UNITED STATES  
NUCLEAR WASTE TECHNICAL REVIEW BOARD  
2300 Clarendon Boulevard, Suite 1300  
Arlington, VA 22201

October 21, 2003

## ATTACHMENT TO OCTOBER 21, 2003, LETTER FROM THE BOARD TO DR. CHU

CP of Alloy 22 in CaCl<sub>2</sub> Brines (No Nitrate)

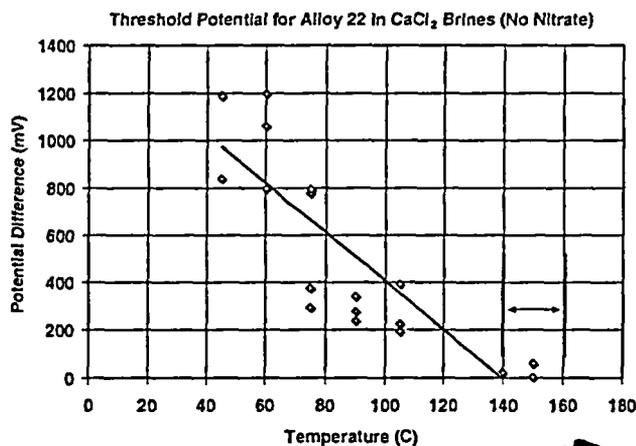
This figure is an overhead from Dr. Farmer's presentation at the January 28, 2003, Board meeting in Las Vegas. Localized corrosion is virtually certain to initiate when the Potential Difference falls below 0. For Alloy 22 in a concentrated solution of calcium chloride with no nitrate added, the overhead indicates that the Potential Difference is below 0 for temperatures of approximately 140°C and higher. (Peak waste package surface temperatures in the current design are approximately 180°C.)

CP of Alloy 22 in CaCl<sub>2</sub> Brines (No Nitrate)  
(Continued)

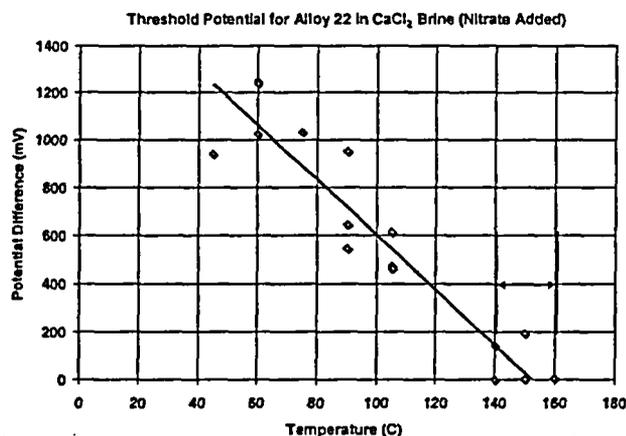
This figure is another overhead from Dr. Farmer's presentation at the January 28, 2003, Board meeting. (There is an error in the title. Instead of "No Nitrate," it should read "Nitrate Added.") Again, localized corrosion is virtually certain to initiate when the Potential Difference falls below 0. For Alloy 22 in a concentrated solution of calcium chloride with nitrate added, the overhead indicates that the Potential Difference is below 0 for temperatures of approximately 150°C and higher.

### Critical Temperature for Localized Corrosion in Artificial CaCl<sub>2</sub> Brine with NO<sub>3</sub><sup>-</sup> Inhibitor

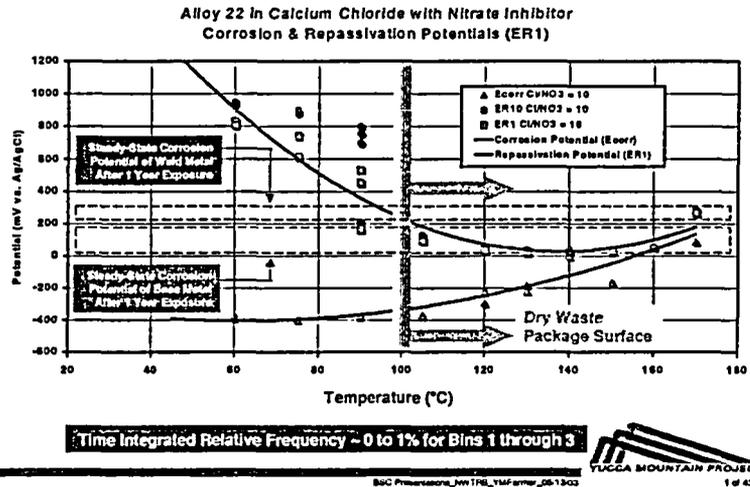
This figure is an overhead from Dr. Farmer's presentation at the May 13, 2003, Board meeting in Washington, D.C. Note the dashed boxes. They indicate that base-metal steady-state corrosion potential moves in a noble (positive) direction with time and that welded-metal corrosion potential moves even farther in that direction with time, indicating increasing susceptibility to crevice corrosion with aging time and in welded structures. Although the overhead appears to state that waste package surfaces are dry above approximately 120°C, deliquescence of salts in the dust on waste package surfaces can cause brines to form at temperatures up to approximately 150°-160°C.

### Localized Corrosion of Mill-Annealed Alloy 22

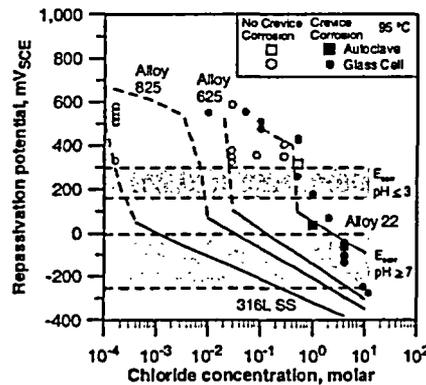
This figure to the right is an overhead from Dr. Cragolino's presentation at the May 14, 2003, Board meeting in Washington, D.C. Note that Alloy 22 is more resistant to localized corrosion than other nickel-chromium-molybdenum alloys (alloys 625 and 825) and than a nickel-chromium alloy (316 stainless steel).

### Effect of Fabrication Processes on Localized Corrosion

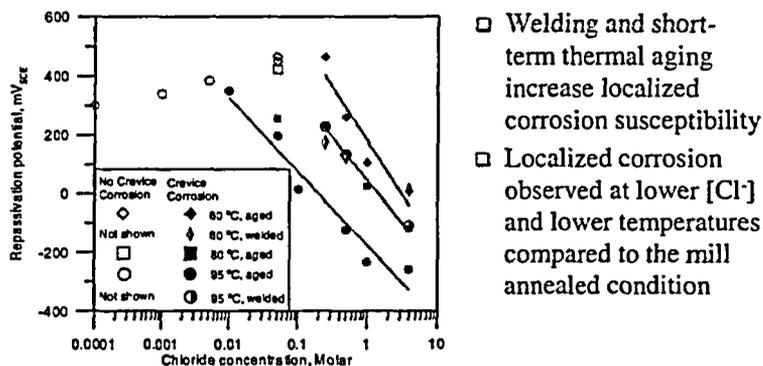
This figure is an overhead from Dr. Cragnolino's presentation at the May 14, 2003, Board meeting. It illustrates the increased susceptibility of welded and thermally aged Alloy 22 in comparison to mill-annealed material.

### Effect of Nitrate on Localized Corrosion of Alloy 22

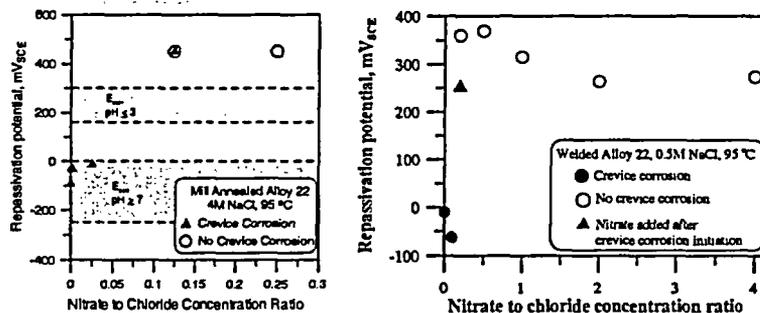
This figure is an overhead from Dr. Cragnolino's presentation at the May 14, 2003, Board meeting. It illustrates the beneficial effect of nitrate on localized corrosion susceptibility of Alloy 22 at 95°C. There is an error in the next-to-last line. Rather than "1.2 for mill-annealed material," it should read "0.12 for mill-annealed material."

## Effect of Temperature on Localized Corrosion

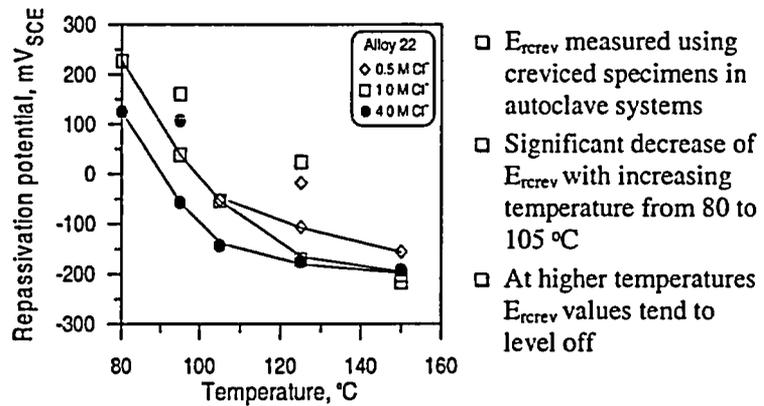
This figure is an overhead from Dr. Cragnolino's presentation at the May 14, 2003, Board meeting. It illustrates how repassivation potential decreases with temperature.
